SUPPORT OF COMMANDER'S  
INDEPENDENT THERMAL VIEWER  
(CITV) SOURCE SELECTION

# SUPPORT OF COMMANDER'S INDEPENDENT THERMAL VIEWER (CITV) SOURCE SELECTION

**MEMORANDUM FOR RECORD**

**SUBJECT:** Technical Support of Commander's Independent Thermal Viewer (CITV) Source Selection

EXAMPLE

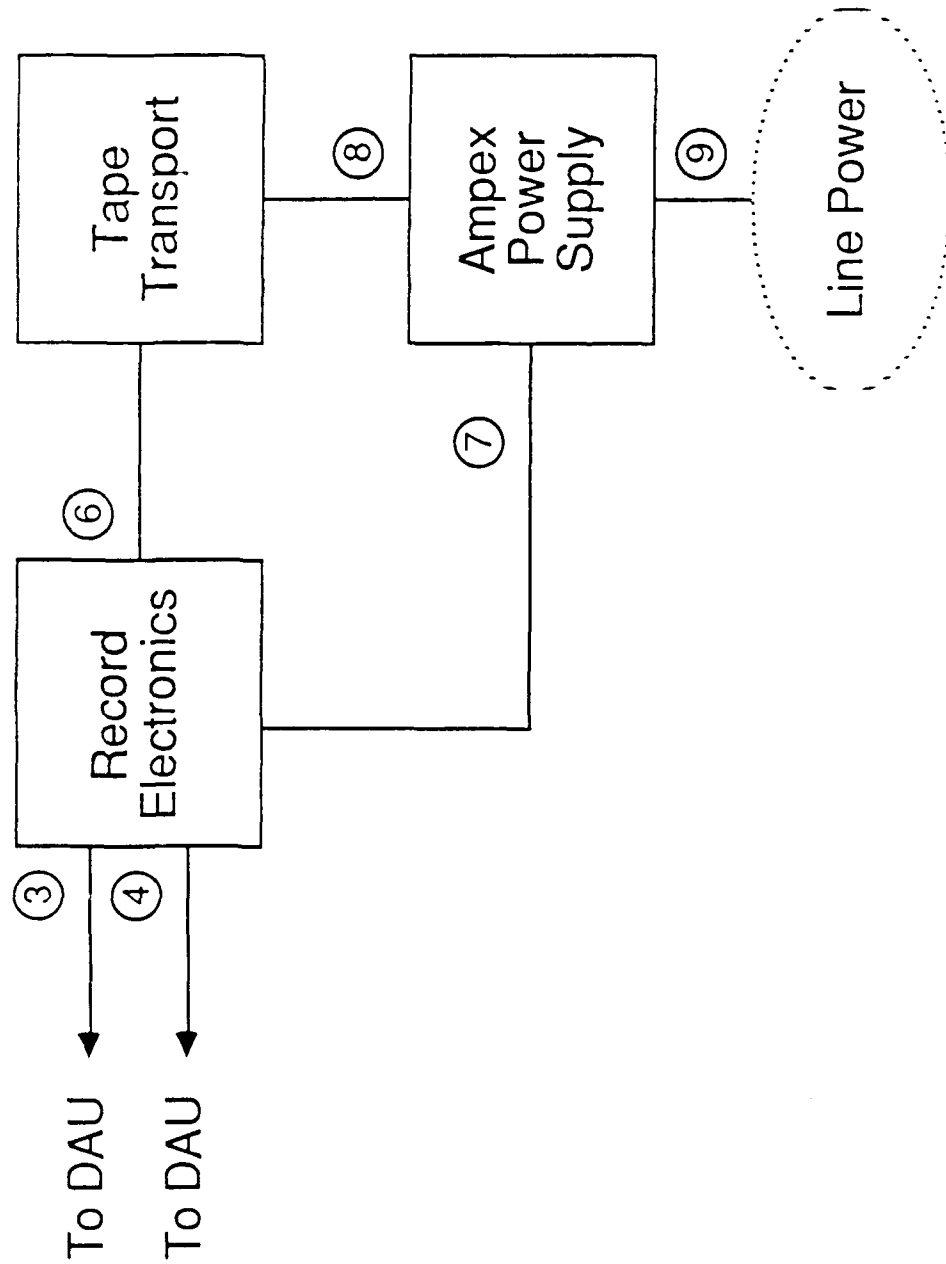
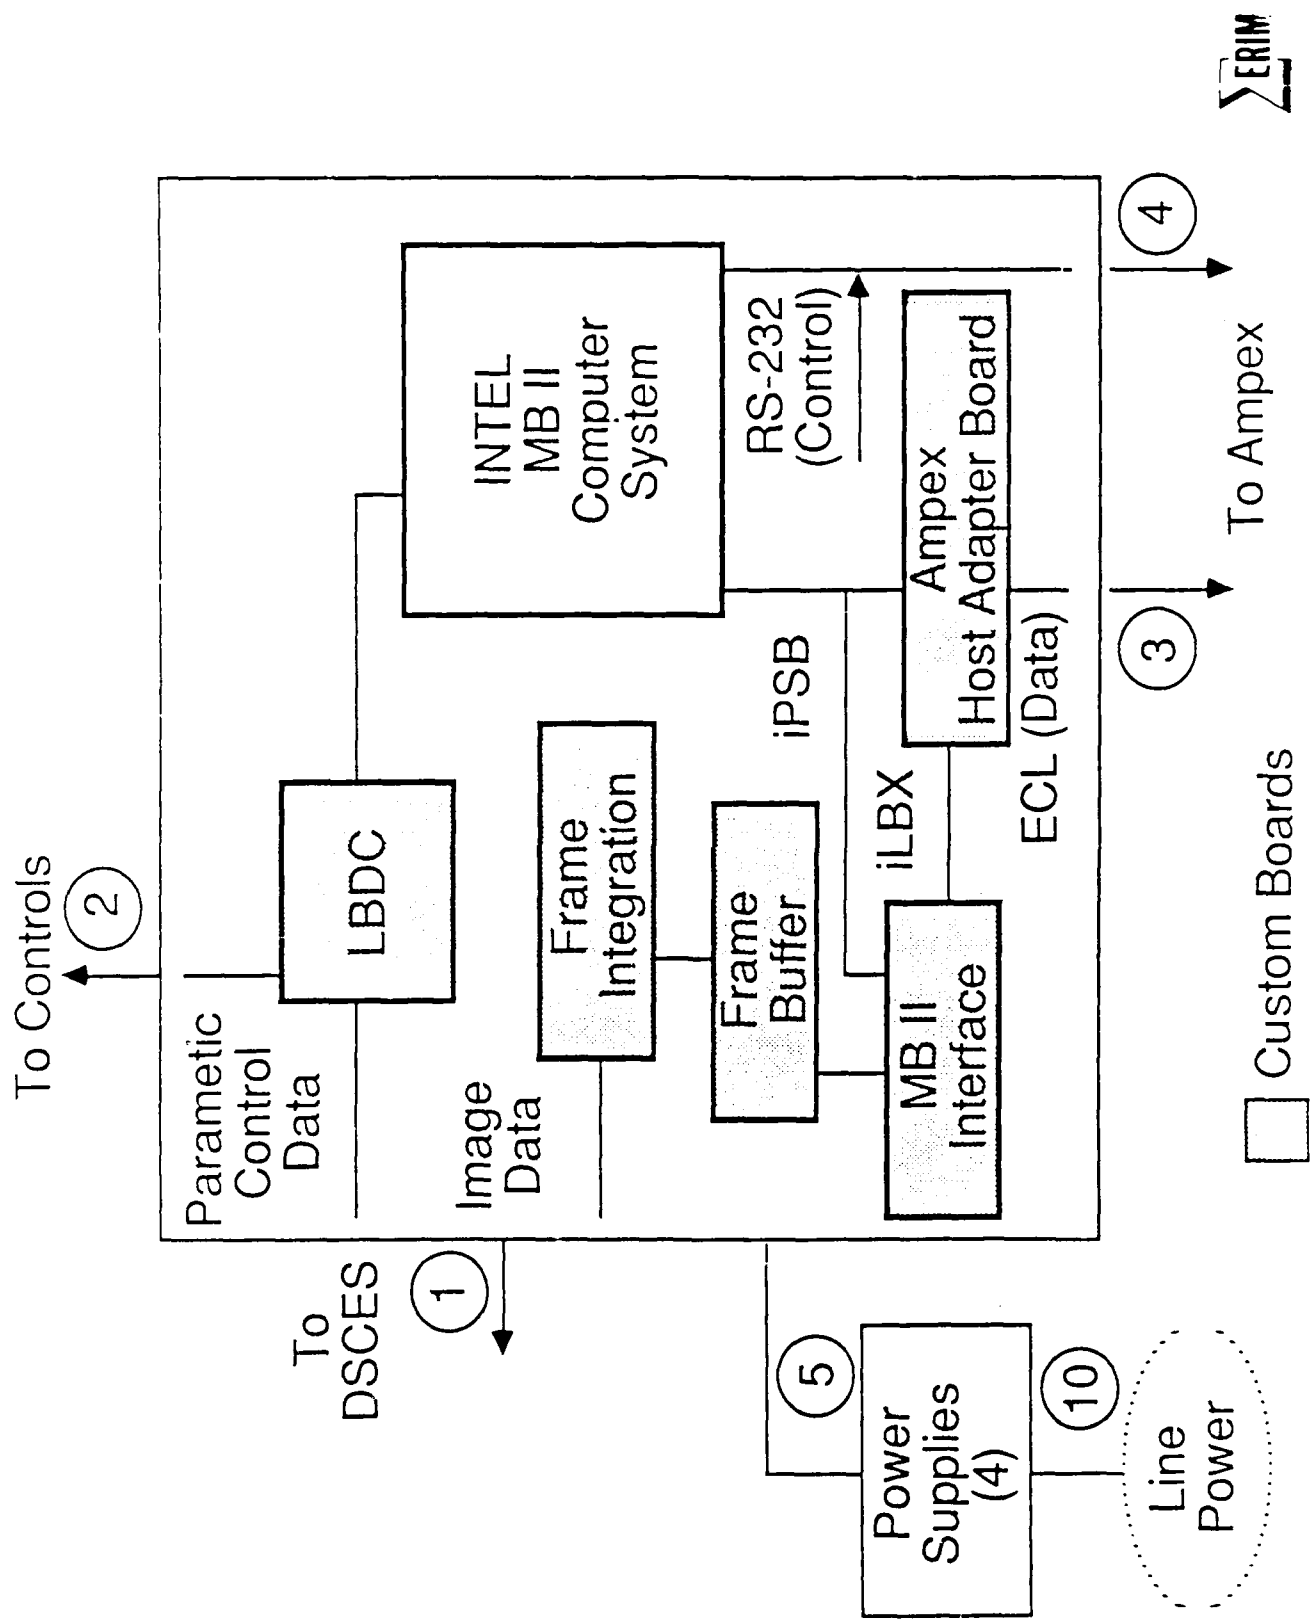
1) Recommend providing hierarchical interconnect and cabling information for the Commander's Integrated Display (CID). An example of a hierarchical interface definition, including an example signal specification, is attached. For specification of each individual electrical connection, the following additional information should be added:

- Source
- Destination
- Type (bi-directional, Tri-state, etc.)
- Drive impedance
- Load impedance
- Frequency
- Direction
- Technology (TTL, ECL, Analog, etc.)
- Timing diagrams
- Special terminations

Figure 1: Direct Sunlight Through Vision Block - Top View

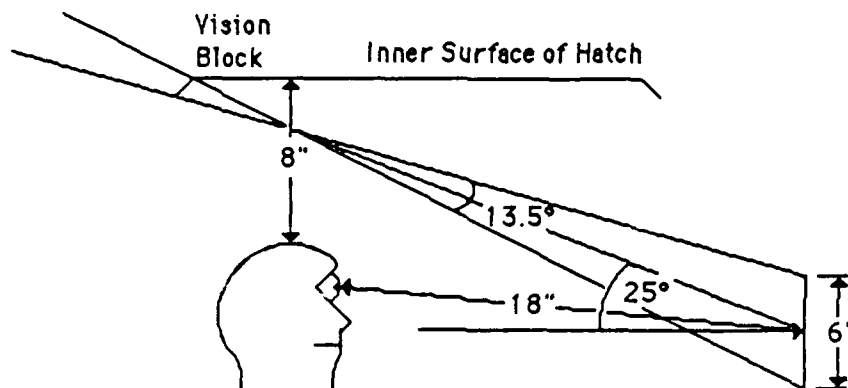
Two figures are attached which show an estimation of the probability of having direct sunlight illuminate the display while the hatches are closed. For Figure 1, it is assumed the turret has equal probability of being in any rotational position with respect to the sun -- accounting for the 360 degrees in the denominator. Of this 360 degrees, only 85 degrees represent a position where the sun could pass via one of the vision blocks and hit the display. This angle represents the angle between the first and last rays to touch the screen and takes into account that the incident beam is not a point. As shown in Figure 2, the angle of incidence is likely to be on the order of 25 degrees with respect to the surface normal -- assuming that the face of the display is vertical. Also, since the rays from the sun are essentially parallel, the size of the beam is the clear aperture of vision block projected onto the display. The angle shown in the side view can be related to the hours during which the sun could shine directly on the display given the season and latitude. Based on the estimates used, it is possible that at the polar regions (greater than 85 degrees latitude), during the summer and on clear days, the sun will be within this angle 24 hours a day. For latitudes below 50 degrees this number is more likely to be on the order of 2-4 hours per day throughout the year.

The sun must be within the 85° azimuth wedge to fall directly on the display.

$$\% \text{probability} = \frac{85^\circ}{360^\circ} \times 100 \approx 24\%$$

- 1) More exact calculations are possible if more accurate information regarding the geometric relationships is made available. This may be essential if the conclusions drawn from the test critically impact operational performance, the display design, and specification. In general, we recommend supplying the display manufacturer

with drawings which show the important geometrical relationships, including the possible positional variation of the commander's eye.

- 2) Full operational performance in direct sunlight can be specified. This option appears to be the least desirable as it requires a significant design (cost) effort to alleviate a problem which will occur very infrequently.

- 3) Acceptable performance (lower than full operational performance) in direct sunlight can be specified.
- 4) Operation in direct sunlight can be requested and costed as an option, with the display manufacturer providing anticipated performance at additional cost.

- 5) Ask the Army to make an operational assessment of these conclusions, and proceed on their recommendation.
- 6) Modify the ICWS vision blocks to include flaps which can be readily open or closed. This has the added advantage of allowing secure operation with the lights on inside the turret or with a reasonable brightness on the display. This option is beyond the scope of the CID; however, it eliminates an intermittent but significant problem, probably creates only a minor operational annoyance, and can be accomplished with minimal design effort.
